SOLICITATION ADDENDUM #5

Addendum Issuance Date: July 21, 2022
Solicitation Number: RFP PTD22-001
Offer Due Date: Revised by this addendum to Monday, August 22, 2022, at 2:00 p.m. MST (Local Time)
Title: Green Transit Technology

City of Phoenix
Public Transit Department
302 North 1st Ave.
Suite 900
Phoenix, AZ 85003
PTDProcurement@phoenix.gov

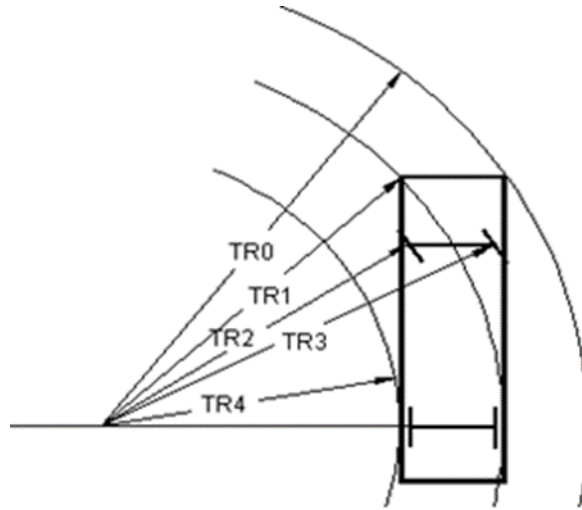
3. Section 6.6.1 (Dimensions, Physical Size of Transit Bus) is revised as follows:
With the exception of exterior mirrors, marker and signal lights, bumpers, fender skirts, washers, wipers, and rub rails, the bus shall have the following overall dimensions at static conditions and design height:
 - Body Length: **40 feet, +/- 4 inches (preferred) or up to 41 feet, 5 inches (maximum)**
 - Body Width: 102 inches (+0, -1 inch)
 - Maximum Overall Height: 140 inches, includes all rigid roof mounted items (such as HVAC, exhaust, fuel system and cover, etc.)
 - Turning Radius - see diagram below:
 - 525 inches maximum +/- 5% (outside TR0)
 - **Inside TR4: 275 inches +/- 5% (preferred) or up to 326 inches (maximum)**

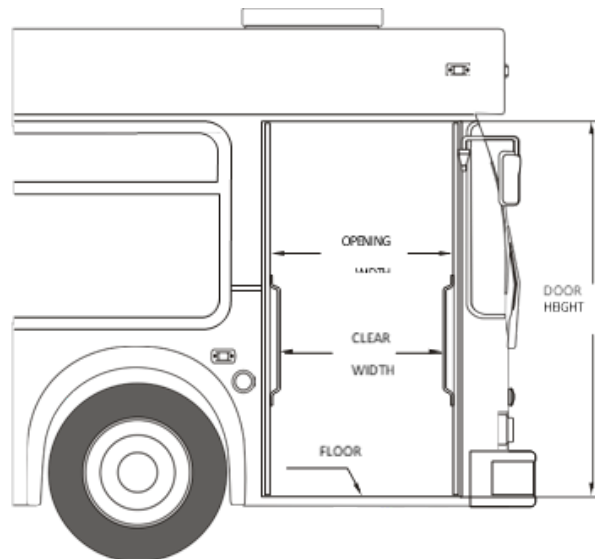
- Clear Door Opening (excluding grip rails) – see diagram below:
 - Front: 32 inches minimum
 - **Rear: 33.5 inches (minimum) or equal to or greater than 36 inches (preferred)**

Figure 1 below is provided as an illustrative guide to instrument and control grouping. Final design will be approved by the CITY during **pre-production** meetings.

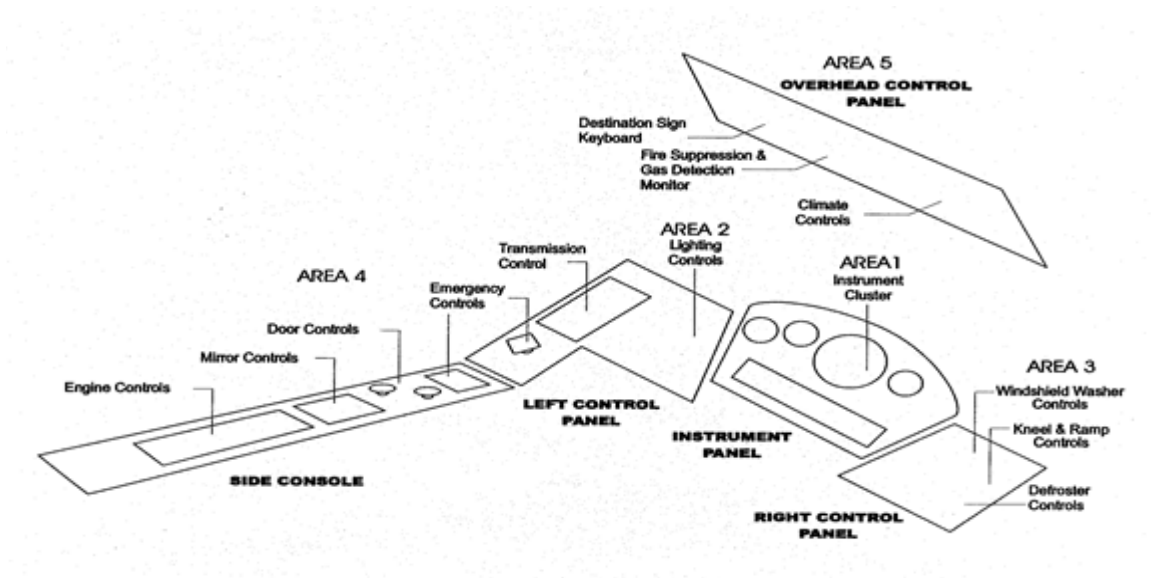
14. Section 6.30.9 (Controls Location) is revised as follows:

- Area 2 (**Preferred**): Operational controls and switches, including transmission controls and lighting switches, located adjacent the left side of the instruments.

- **Area 2 (Minimum): Operational controls and switches, including transmission controls, located adjacent the left side of the instruments (lighting switches moved to Area 4).**

- **Area 2 (Minimum): Operational controls and switches, including transmission controls, lighting switches, and operator's climate controls, located adjacent the left side of the instruments (operator's climate controls moved from Area 3)**

- **Area 2 (Minimum): Operational controls and switches, including transmission controls, and operator's climate controls, located adjacent the left side of the instruments (lighting switches moved to Area 4 and operator's climate controls moved from Area 3)**

- Area 3 (**Preferred**): Operational controls and switches, including washer controls, kneel and ramp switches, and operator's climate controls, located adjacent the right side of the instruments.

- **Area 3 (Minimum): Operational controls and switches, including washer controls and kneel and ramp switches, located adjacent the right side of the instruments (operator's climate controls moved to Area 2).**

- Area 4 (**Preferred**): Secondary operating controls including door controls, emergency controls and flashers, and mirror and engine controls, located to the left of the operator ahead of the Seat Reference Point (SRP) of the 5th-percentile female.

- **Area 4 (Minimum): Secondary operating controls including door controls, emergency controls and flashers, mirror and engine controls, and lighting switches, located to the left of the operator ahead of the Seat Reference Point (SRP) of the 5th-percentile female (lighting switches moved from Area 2).**

37. Section 6.6.2.8 is revised as follows:

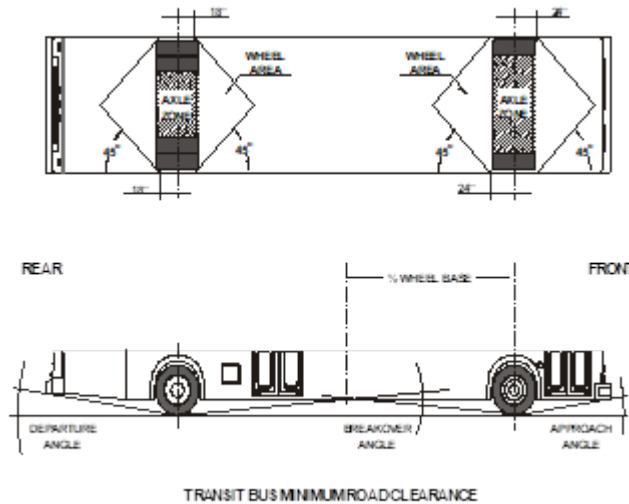
Wheel area clearance shall be **no less than 7.8 inches (minimum) or equal to or greater than 8 inches (preferred) for parts fixed to the bus body** and **no less than 6 inches** for parts that move vertically with the axles.
